II. **P22-071:** 50 S. Cache, 45 & 75 E. Pearl - Development Plan

**MINUTES
PLANNING AND ZONING COMMISSION
TOWN OF JACKSON, WYOMING
May 18, 2022**

Meeting Date:	June 1, 2022	Meeting Title:	Planning Commission
Submitting Department:	Planning Department	Presenter:	Tyler Valentine
Agenda Item:	P22-071 Development Plan for a new 3-story, mixed-use building at the properties addressed at 50 S. Cache Street and 45 & 75 E. Pearl Avenue	Public Comment:	No

Project Number	P22-071	Applied	3/30/2022	AL
Project Name	Dev. Plan - 50 S Cache, 45 & 75 E Pearl	Approved		
Type	DEVPLAN	Closed		
Subtype		Expired		
Status	STAFF REVIEW	Status

PEARL AVENUE ELEVATION

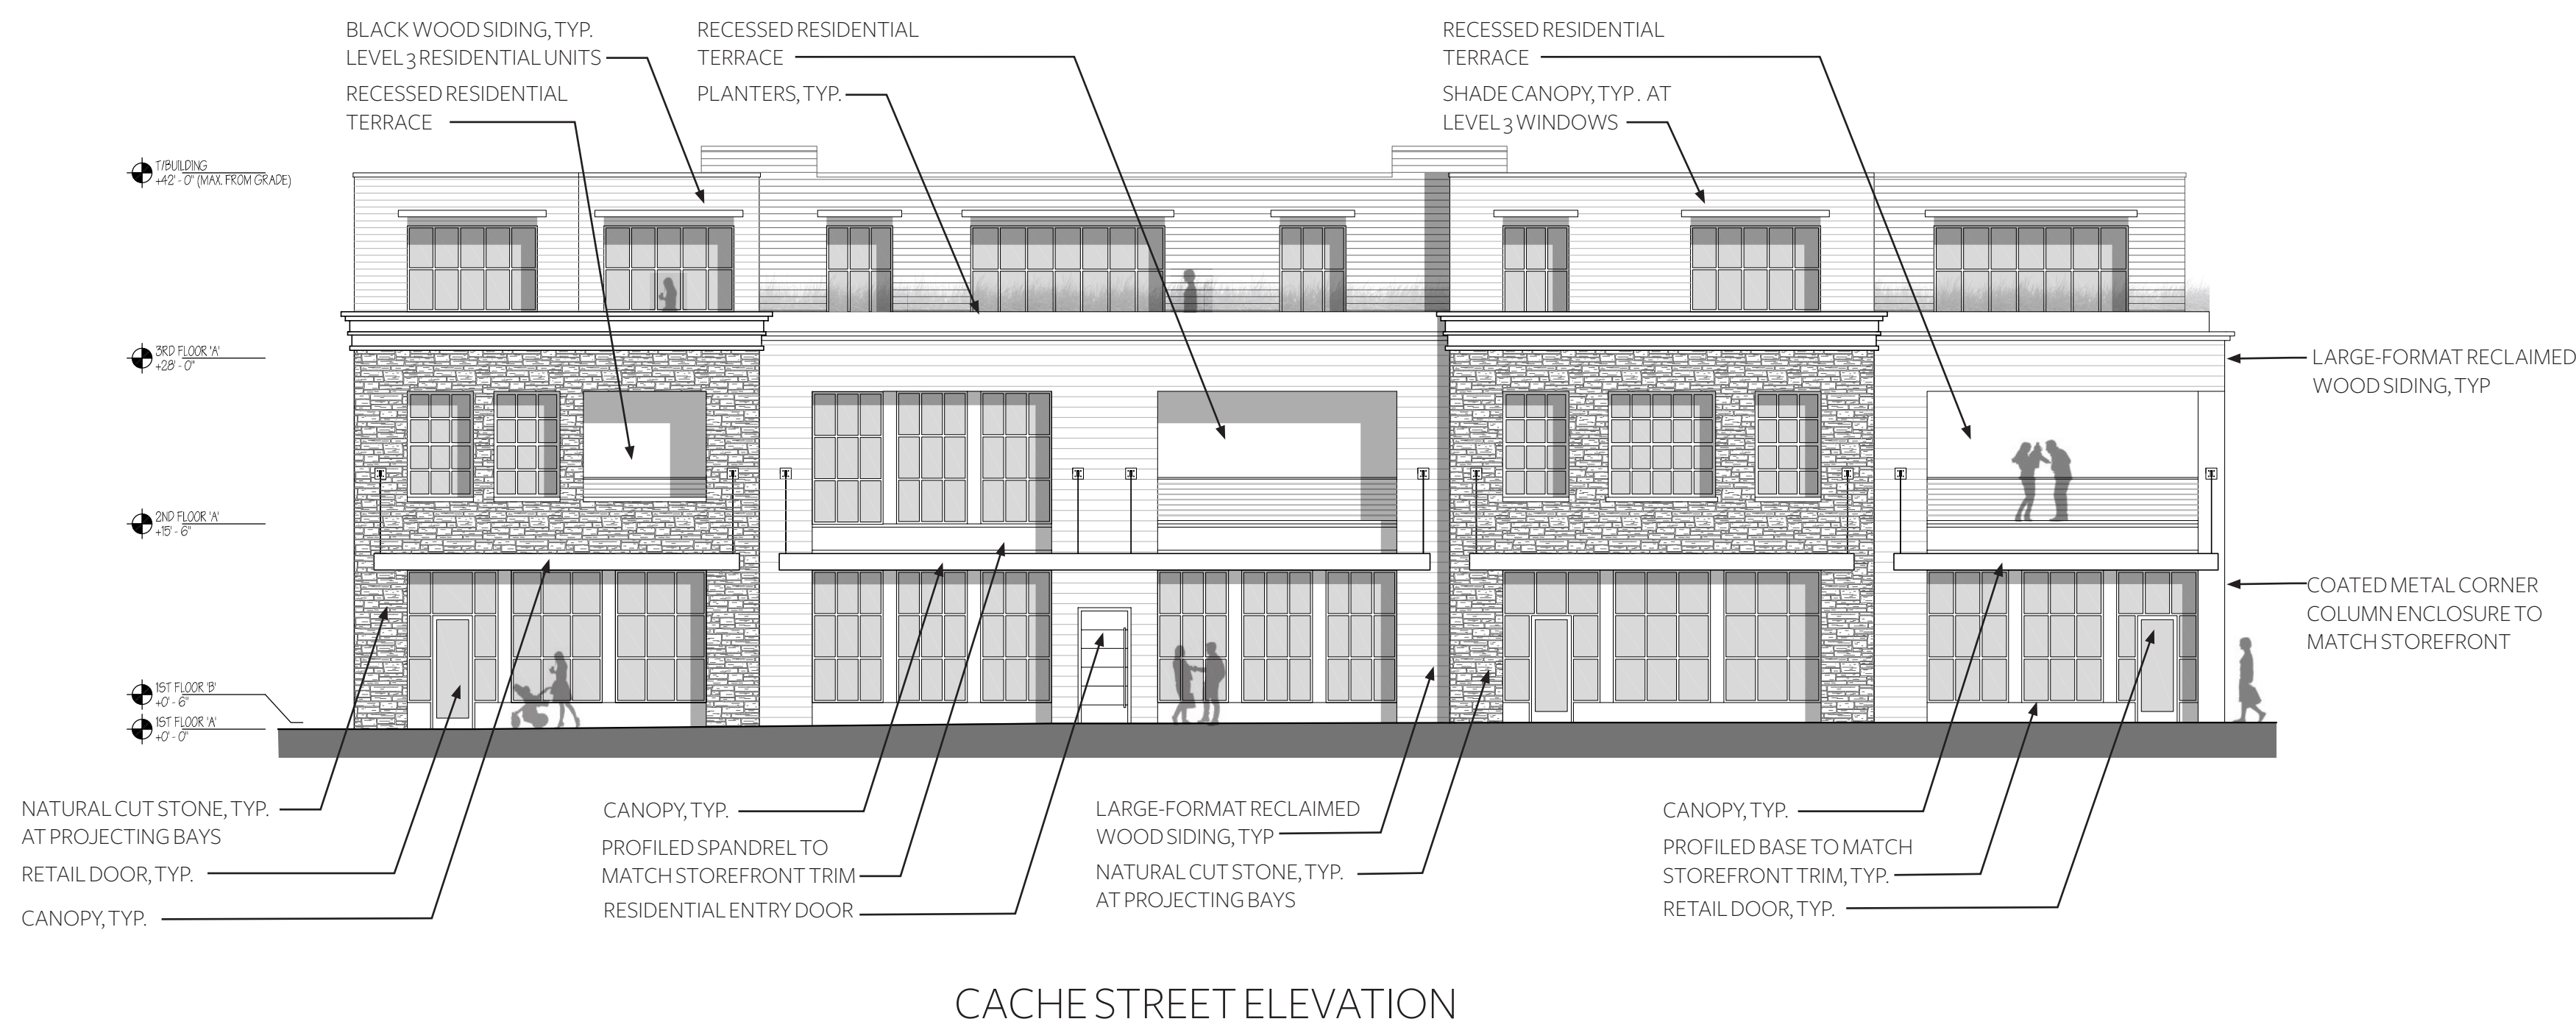
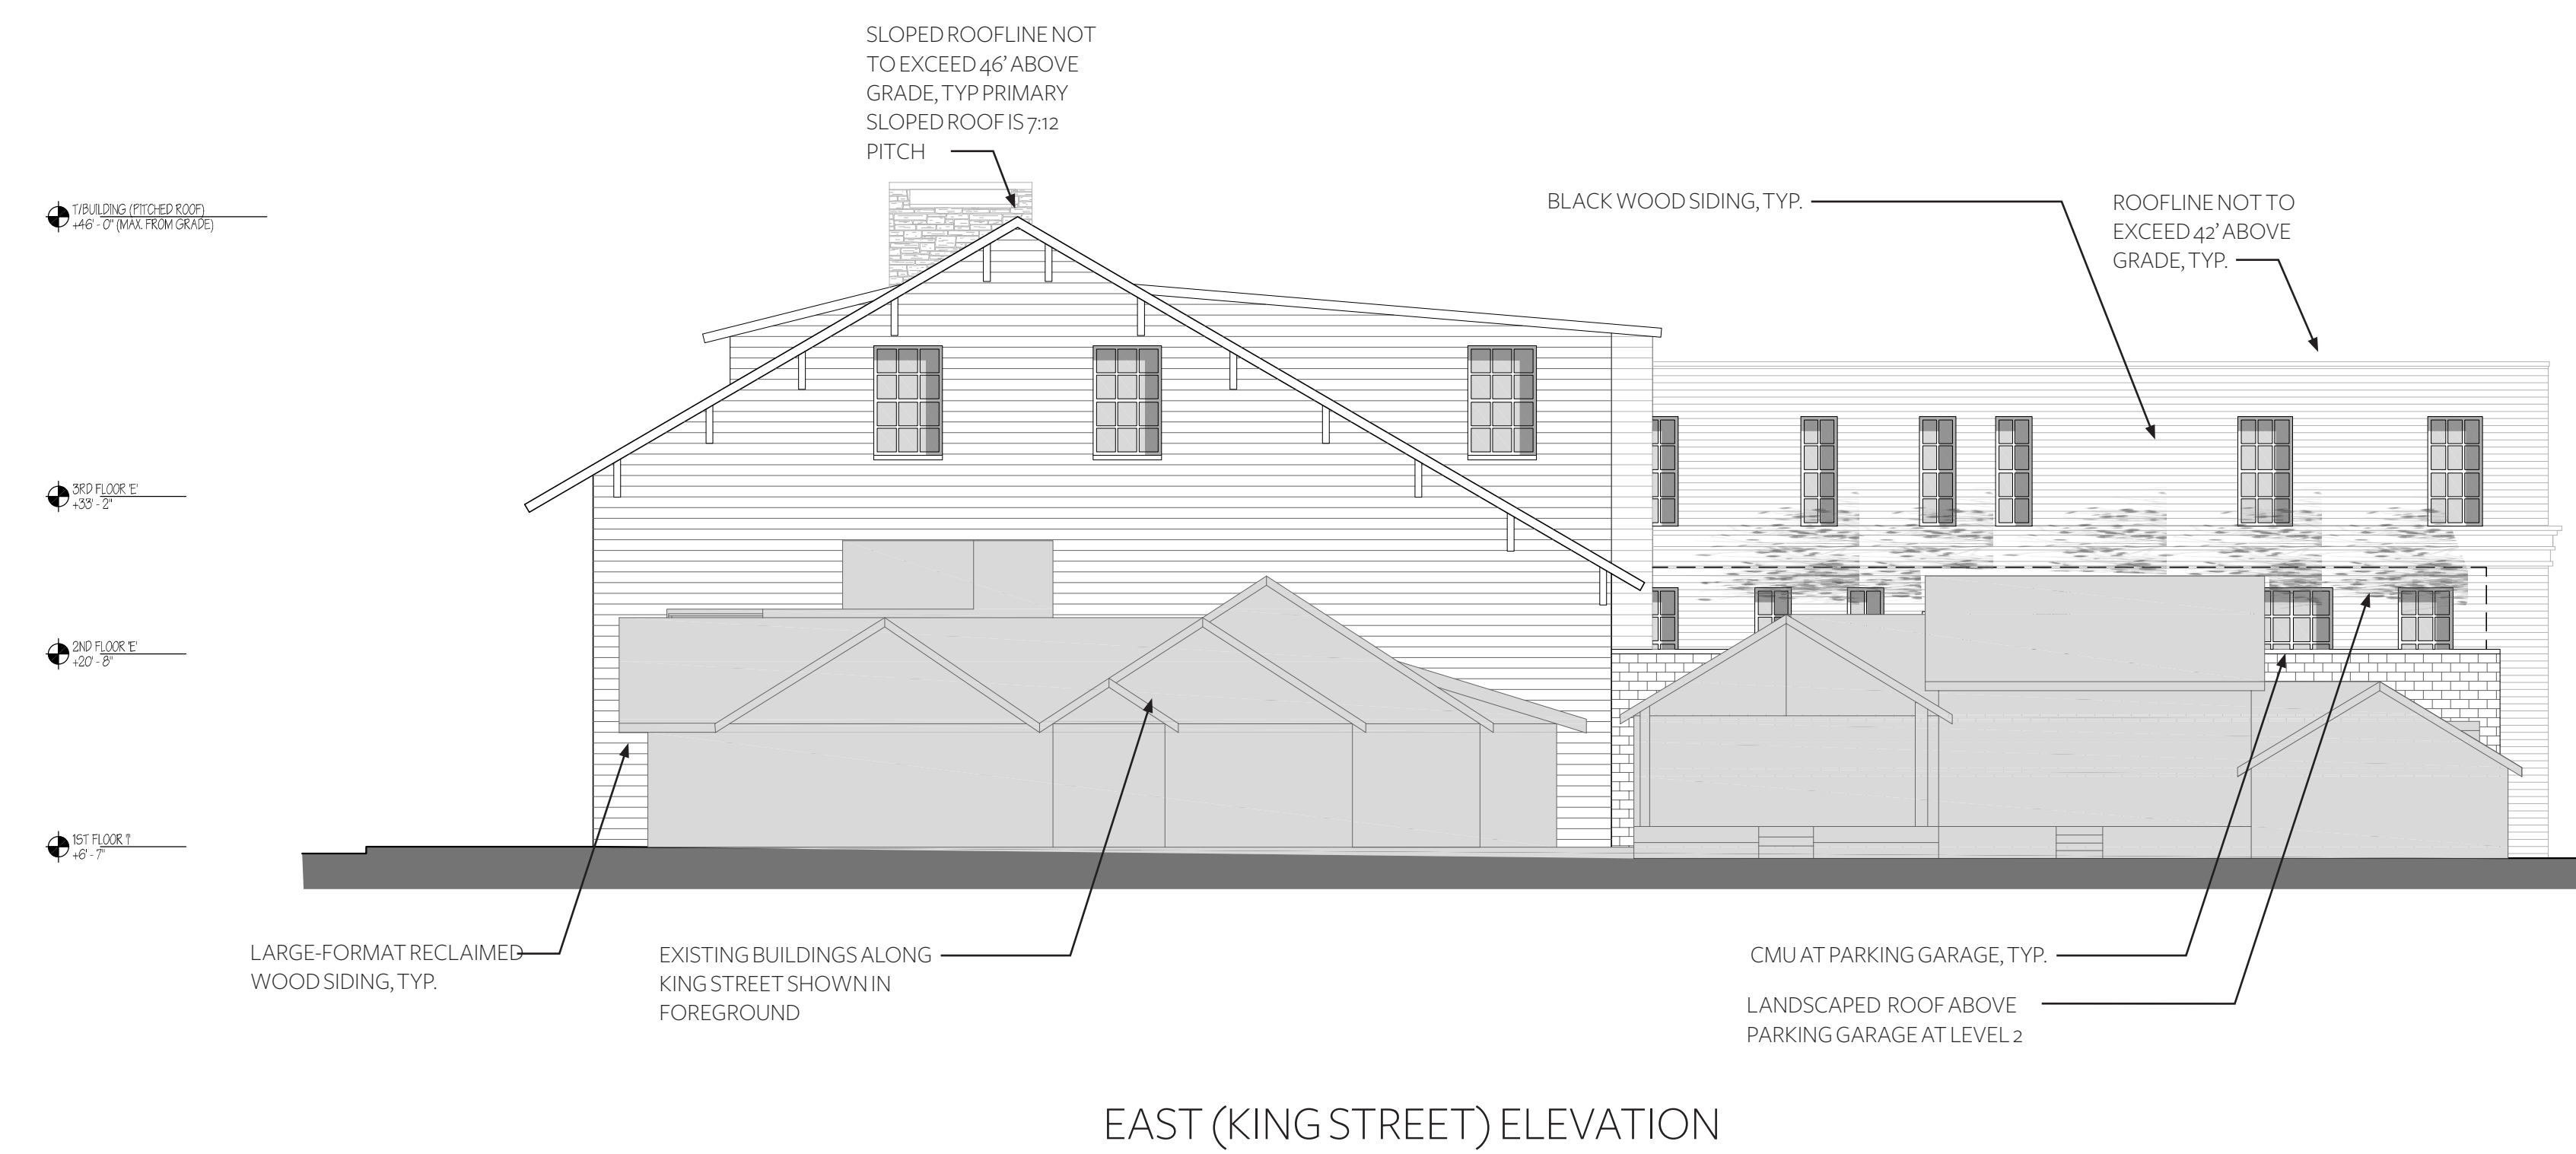
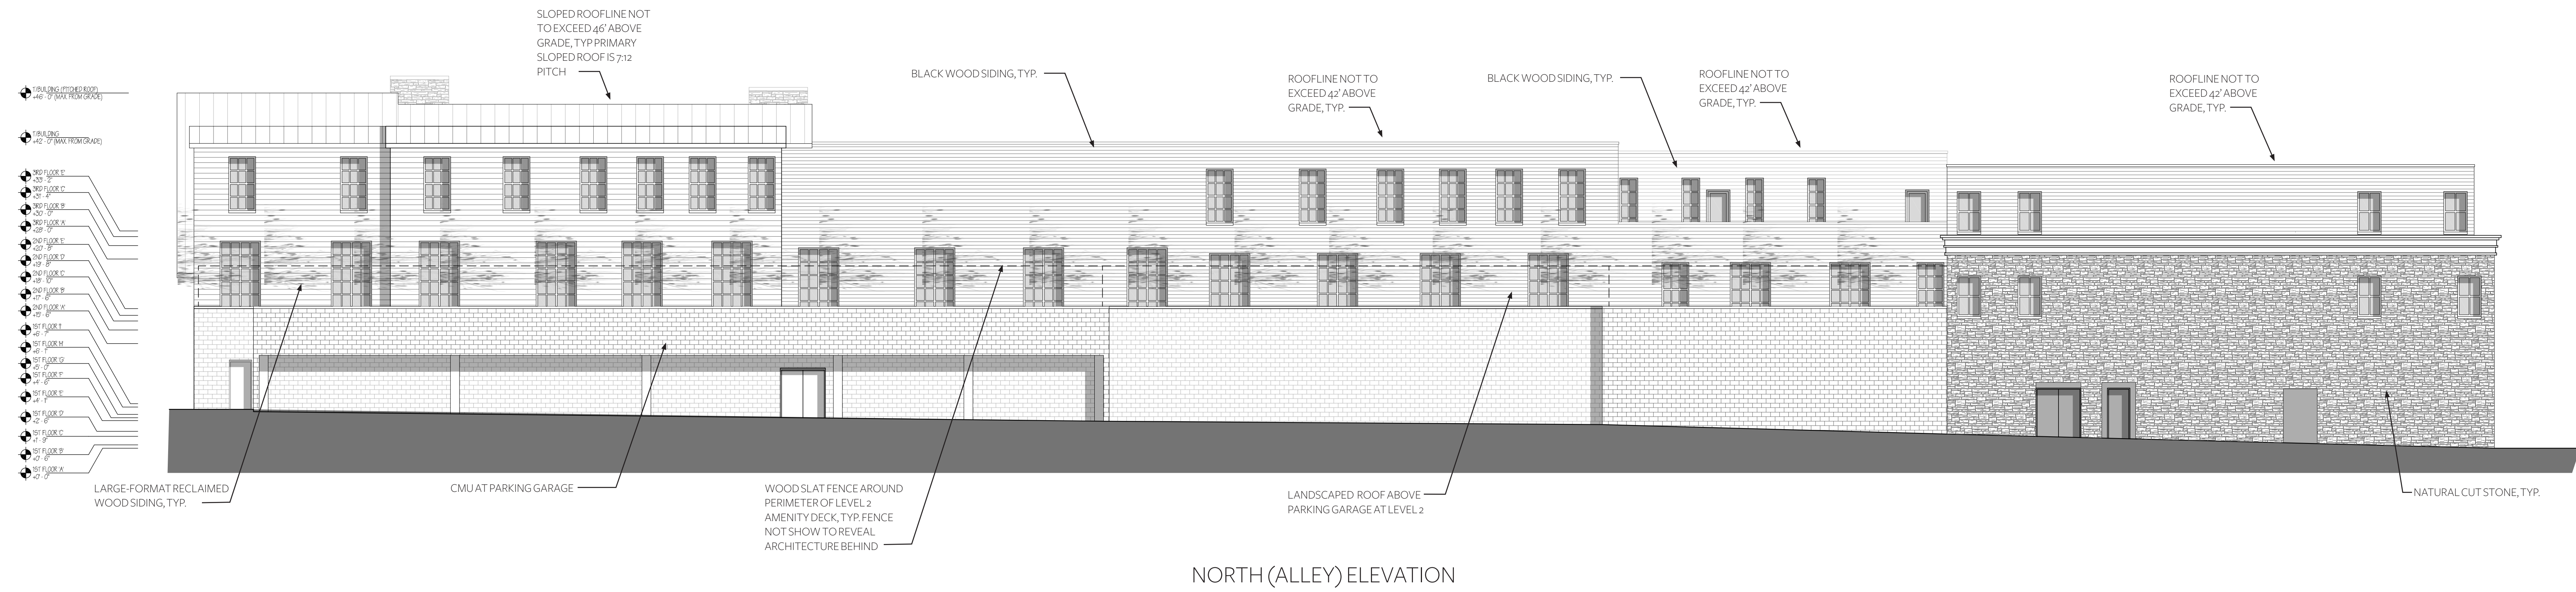
The primary focus of the DRC's review was compliance with Condition #7 of the Sketch Plan which concluded that the large building façade along Pearl Ave still appeared to be too monolithic and lacked sufficient articulation variation to meet the western character design guidelines as well as the Town's general design guidelines. The other part of the Council's Condition #7 addressed the need to increase the level of interest and variety of the building at the street level for pedestrians. The uniform window design and lack of articulation of the shopfront level added to the monolithic feel of the building and so the Council wanted to see some street-level changes there as well. Below is Condition #7:

At the March 2022, meeting the DRC was presented with 2 designs (Option A & B) both of which kept the project as a single building while attempting to break up the building at the 2-story portion on Pearl Ave as mentioned above. In the opinion of the DRC, Option A did not go far enough to meet the Council's condition as it did not successfully break up the building to appear as two buildings or phases. Option A kept the same flat roof pattern as the Sketch Plan design and generally involved pushing the garage door back, setting the first floor back about 10' to create an outdoor area, moving that building module back about 4.5 feet on the second floor, and changing the exterior materials to a black metal panel.

DRAWING NO
C1.1
JOB NO
21-076-03

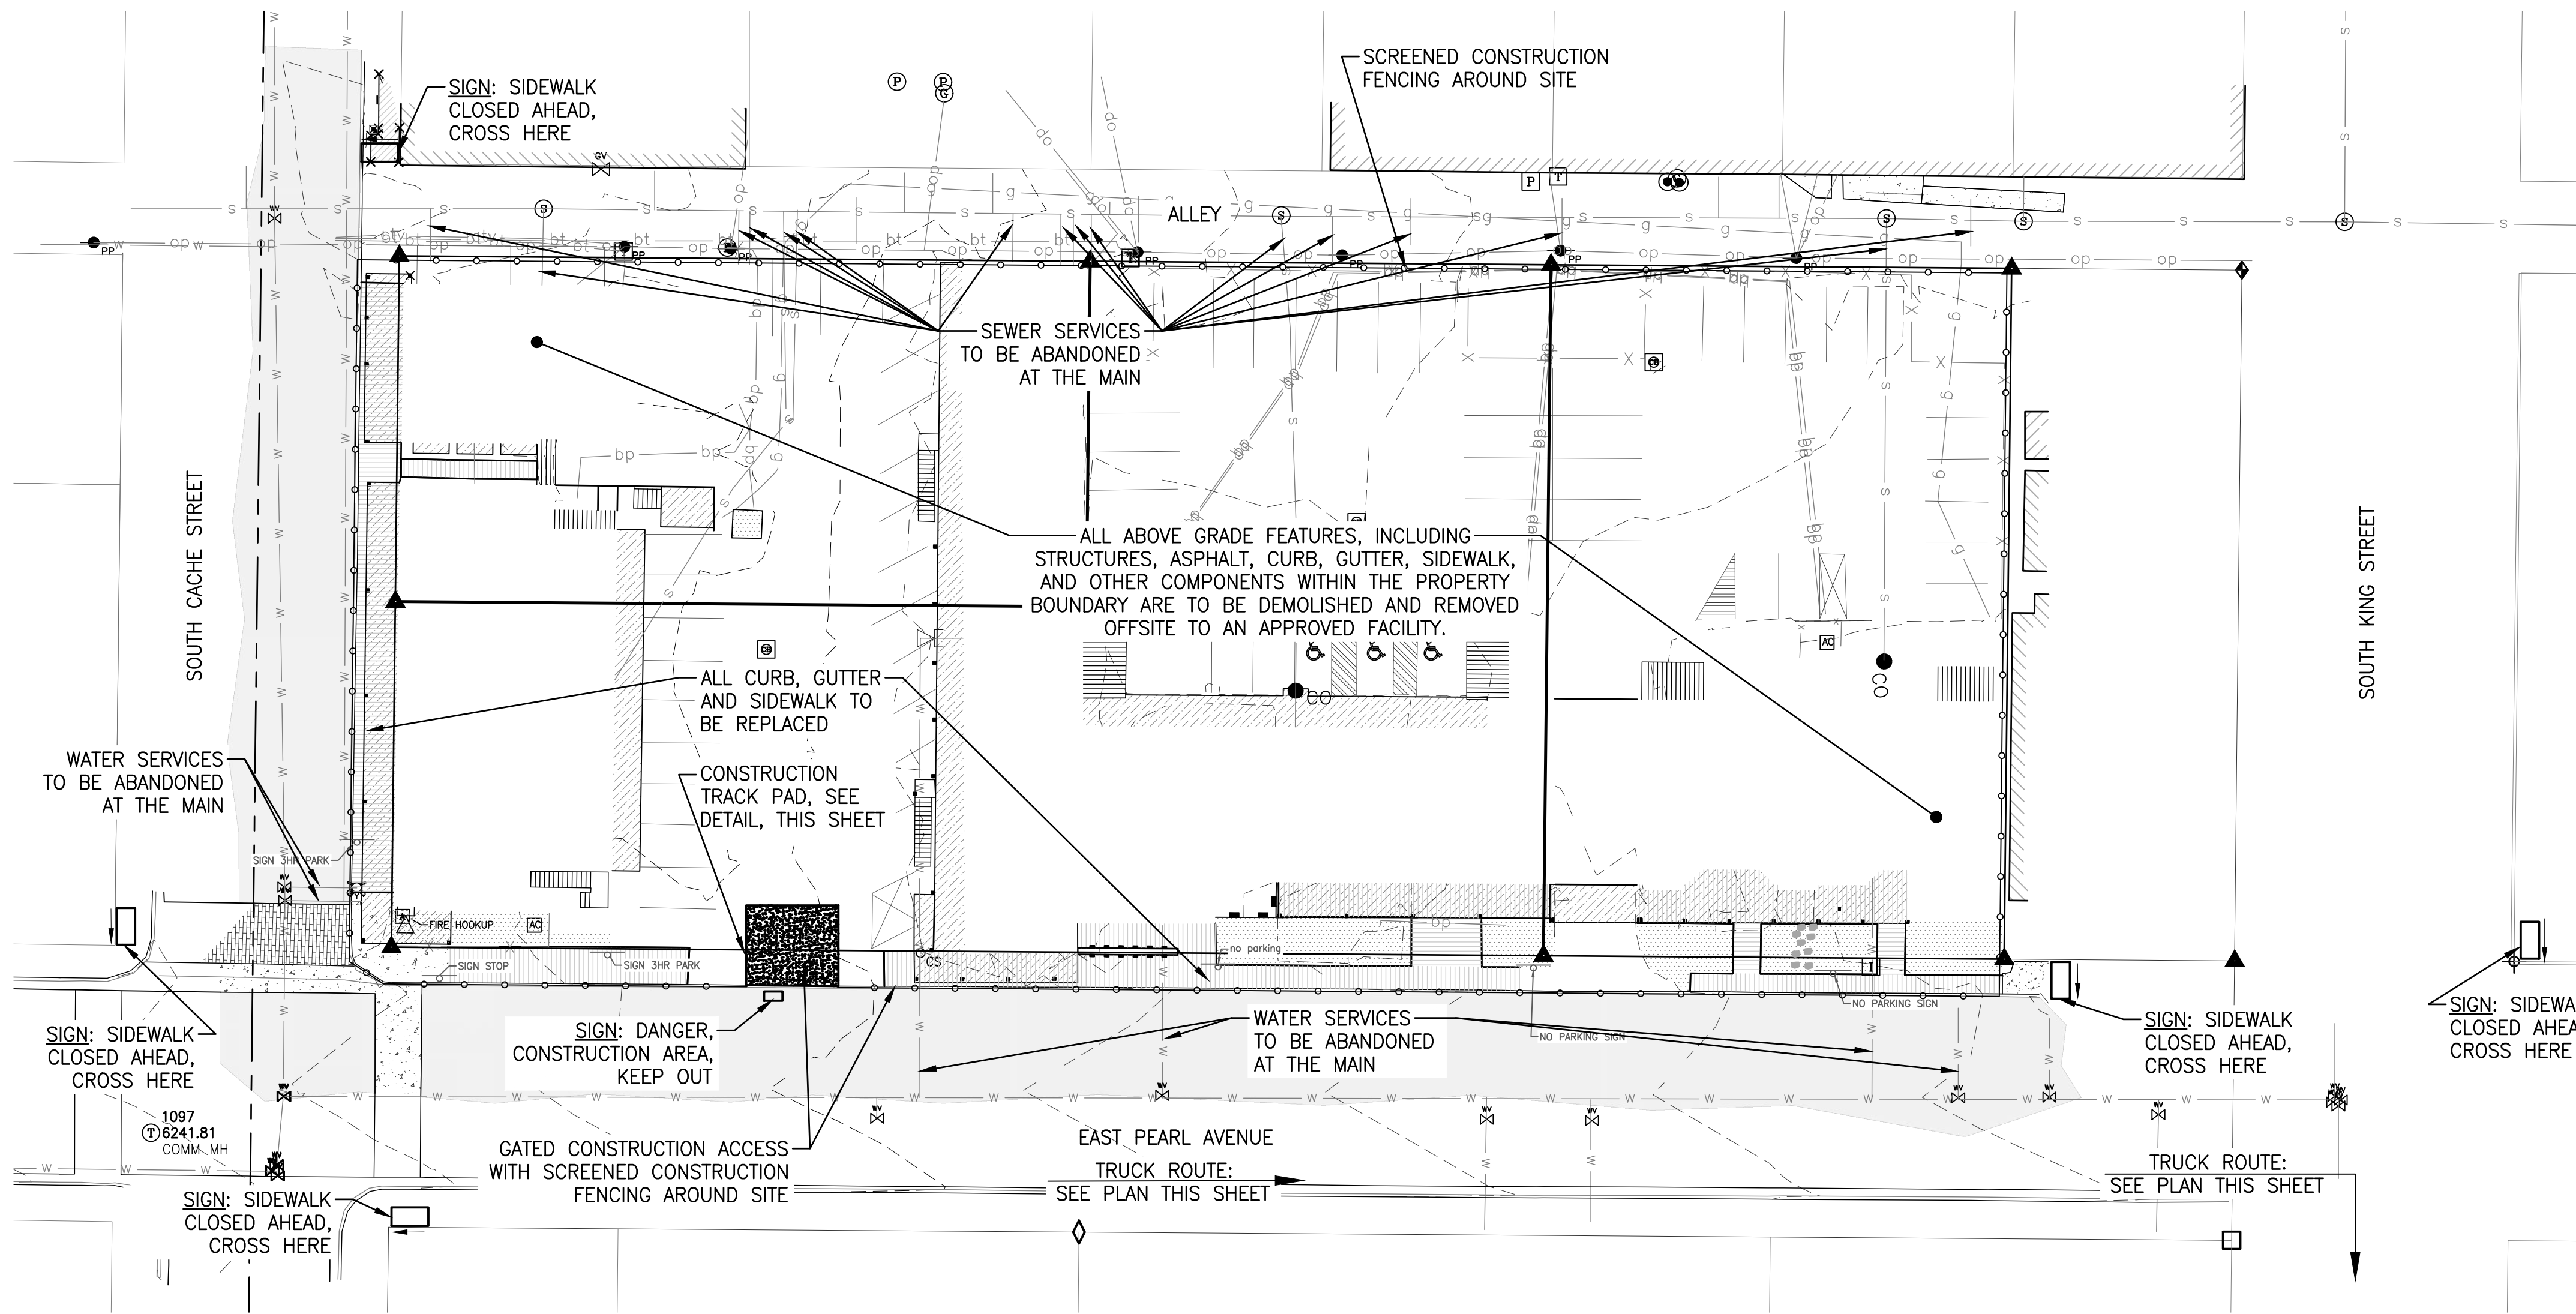
11. Demolition plan notes for construction dates do not correspond with scheduled construction dates in CM Plan. Revise dates accordingly.					
12.

39. Requires WYDEQ Small Construction permit along with a SWPPP.				
40. Revise proposed truck route during the demolition phase. ToJ would prefer loaded trucks to travel on Pearl Avenue rather than the route shown on Sheet C1.1.
